September 9, 2026 Planning and Zoning Meeting Agenda

TO: Planning and Zoning Board

RE: 450 Webster Street

WEBSTER STREET
DEVELOPMENT
BAY ST. LOUIS

SITE PLAN

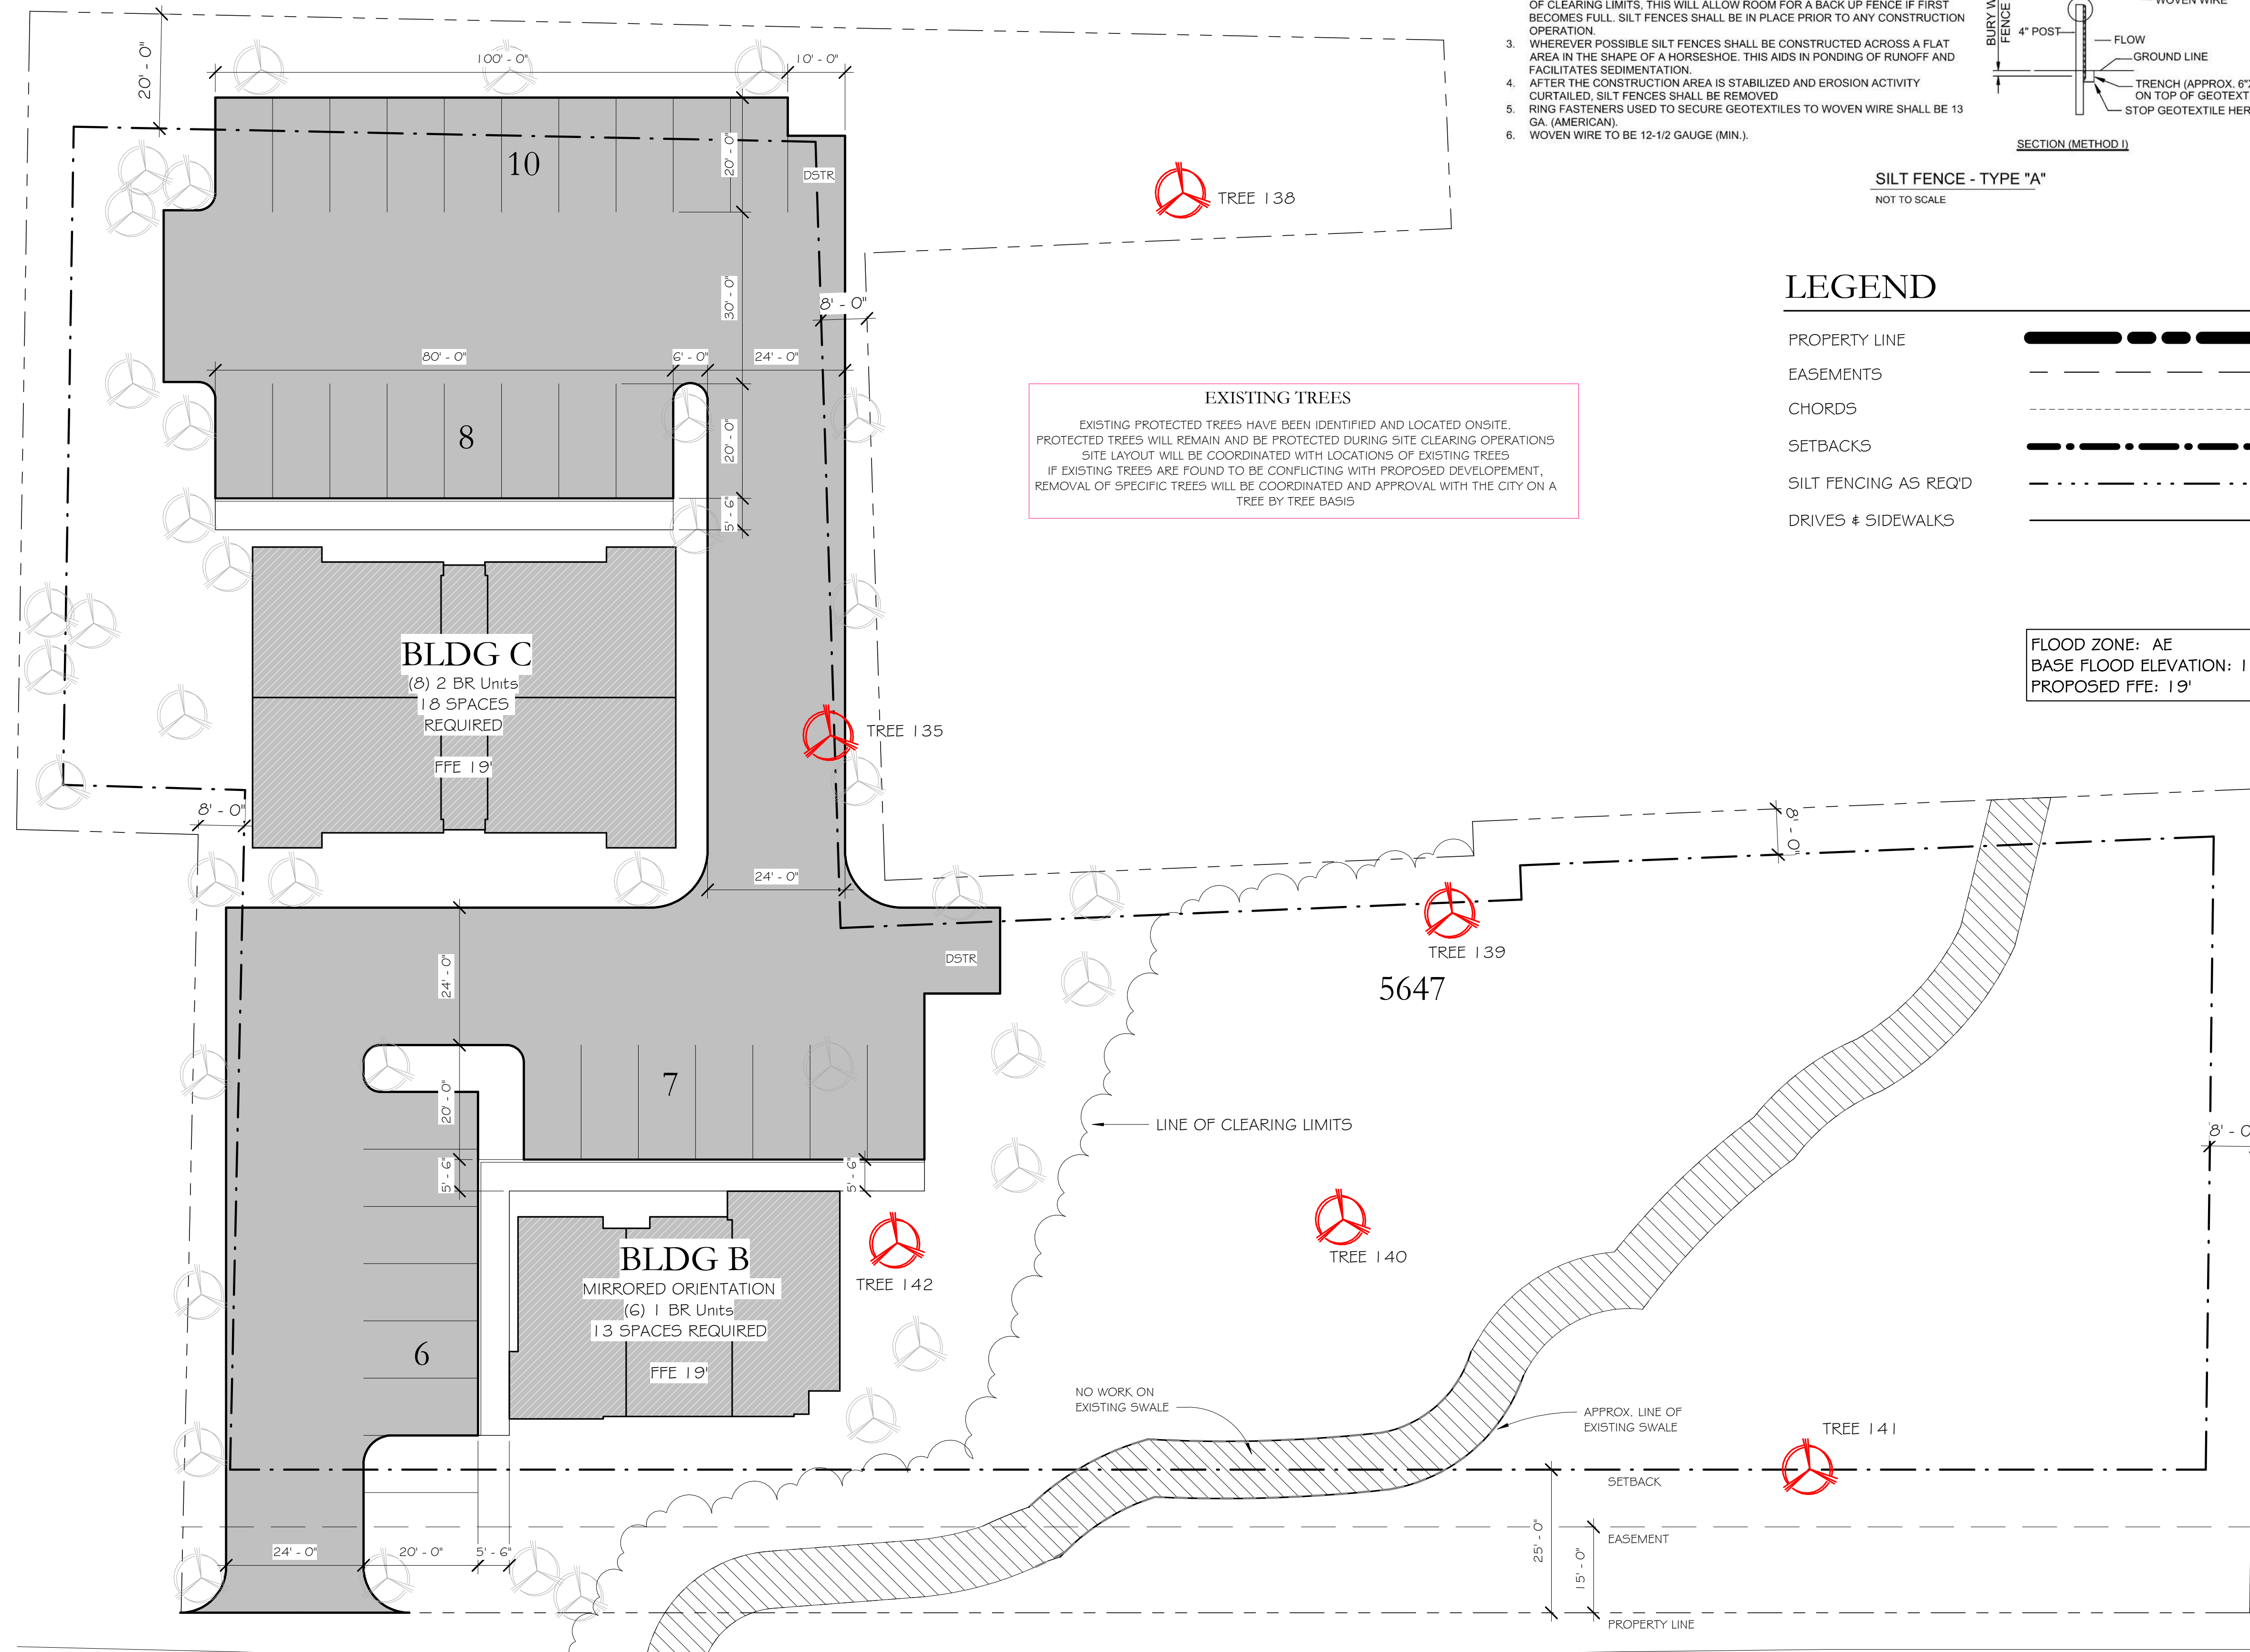
The administration recommends table of the Major Site Plan.

- Condominiums are allowed by-right in this zoning district
- The developer has submitted the drainage analysis for this site plan, but as of 9/3/2026, the drainage plan is under review
- No variances are being requested for this project
- The developer has been in communication with Public Works regarding improvements to the main drainage ditch to improve drainage upstream.
- No wetland are present on the site
- An NAI letter will be submitted before a construction permit is issued

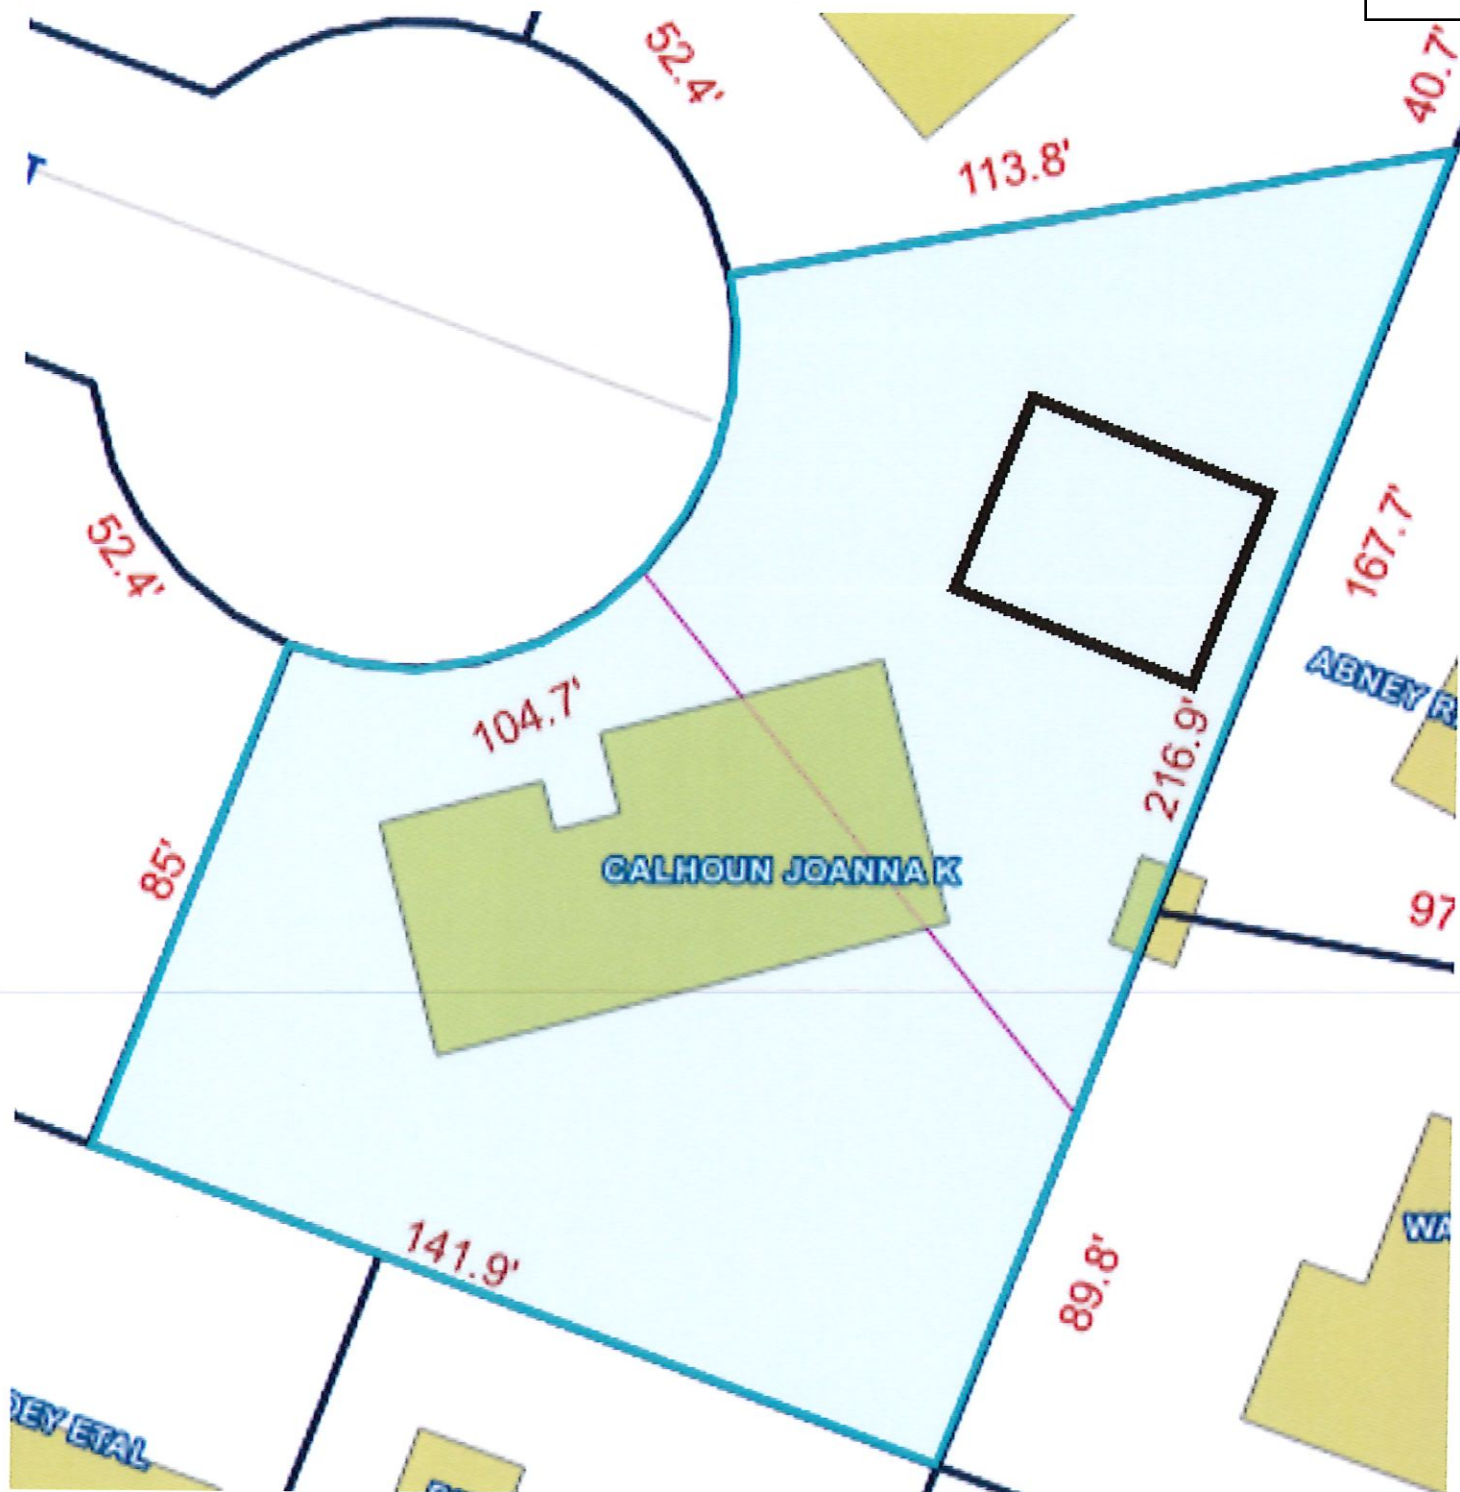
The proposed accessory structure will be 64% of the floor area of the existing residence. A variance of 14% will be needed to allow the accessory structure to exceed the maximum allowed size in relation to the primary structure.

The administration recommends approving the variance.

- The variance will allow a 30'x40', opposed to a 30'x30' shed
- 218 Arcola Court is a double lot, so the property has plenty of room
- No opposition from the neighborhood

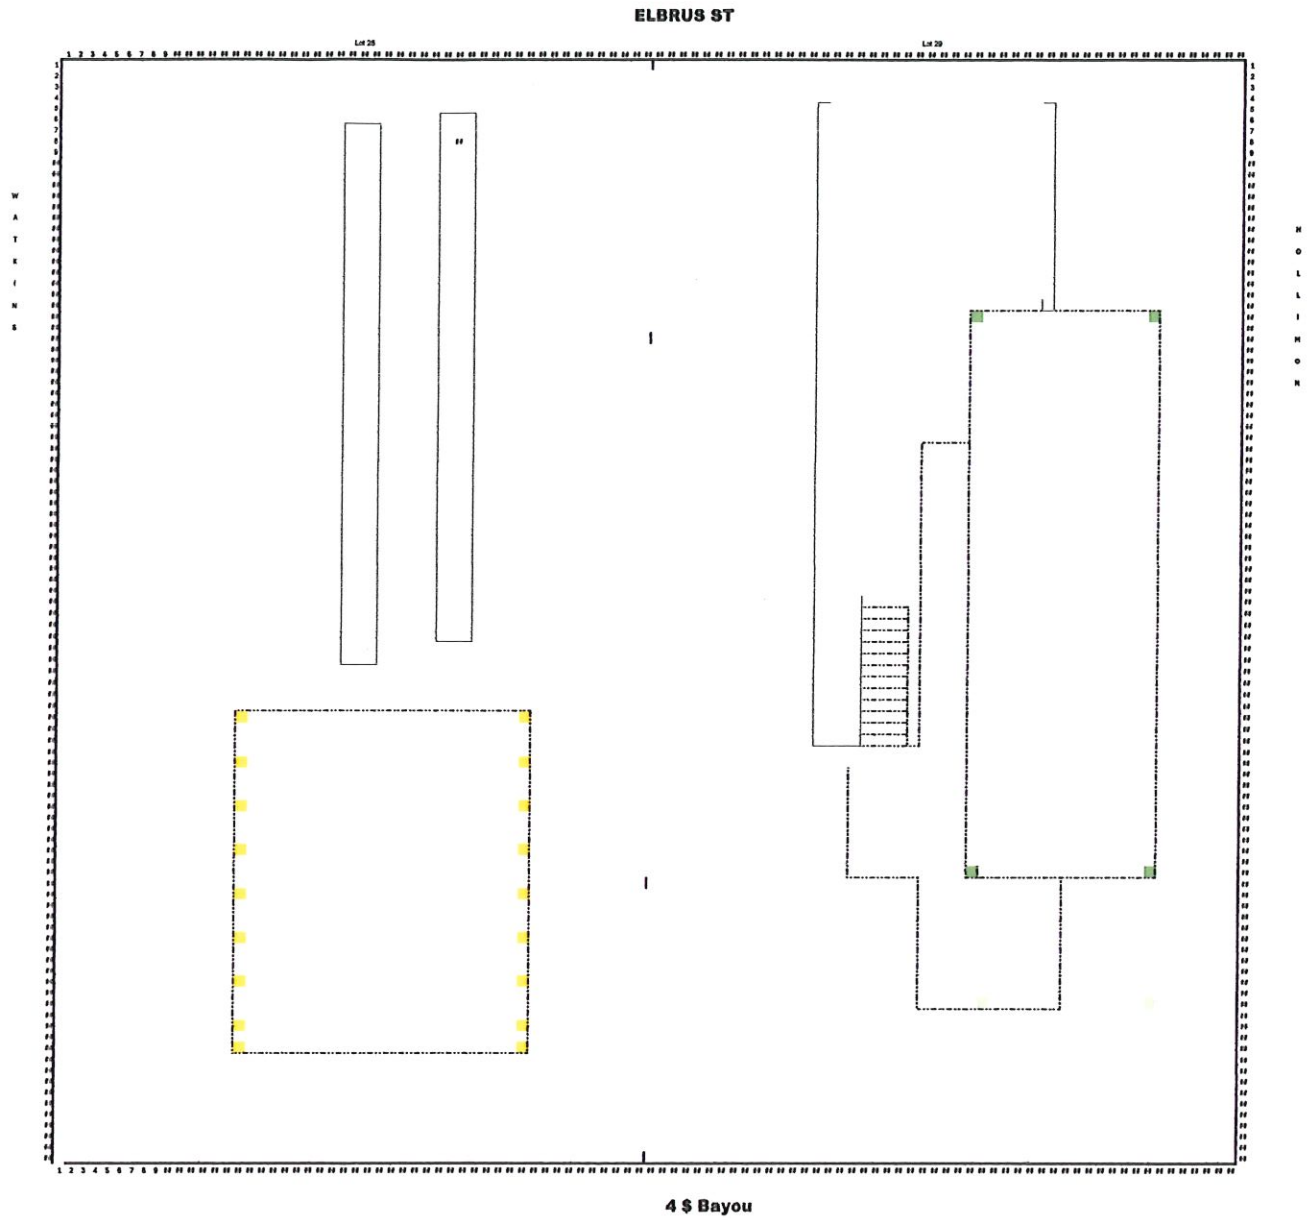
The proposed accessory structure will be 85% of the floor area of the existing residence. A variance of 35% will be needed to allow the accessory structure to exceed the maximum allowed size in relation to the primary structure.

The administration recommends approving the variance.

- Letter of support from a number of neighbors
- This will be open-air storage for two boats
- The dwelling is one 848-square-foot
